Access Compliance Report

Public Rights-of-Way

| Intersection ID: 7375 | Main Street: N_TRYON_ST | Cross Street: TOM_HUNTER_RD | Location: NW |
| ADA ID: DF7B0893F8C8 | Ramp Type: MedianPerp | Initial Pass/Fail: Fail | Overall Compliance: No |

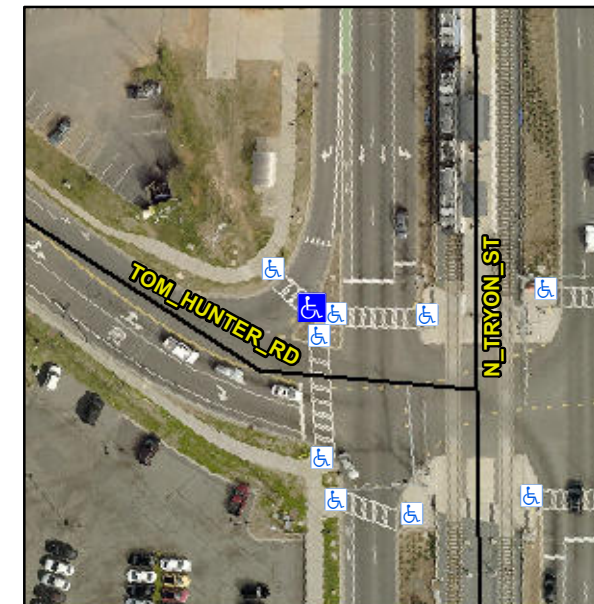
Not Found, R304.5.3

| Compliance | Description | Data | Compliance | Description | Data |
|------------|-----------------------|-------|------------|-----------------------------|------|
| Yes | Ramp Width (in) | 92.0 | No | Ramp XSlope (%) | 3.5 |

Possible Solutions:

Remove & Replace Entire Ramp.
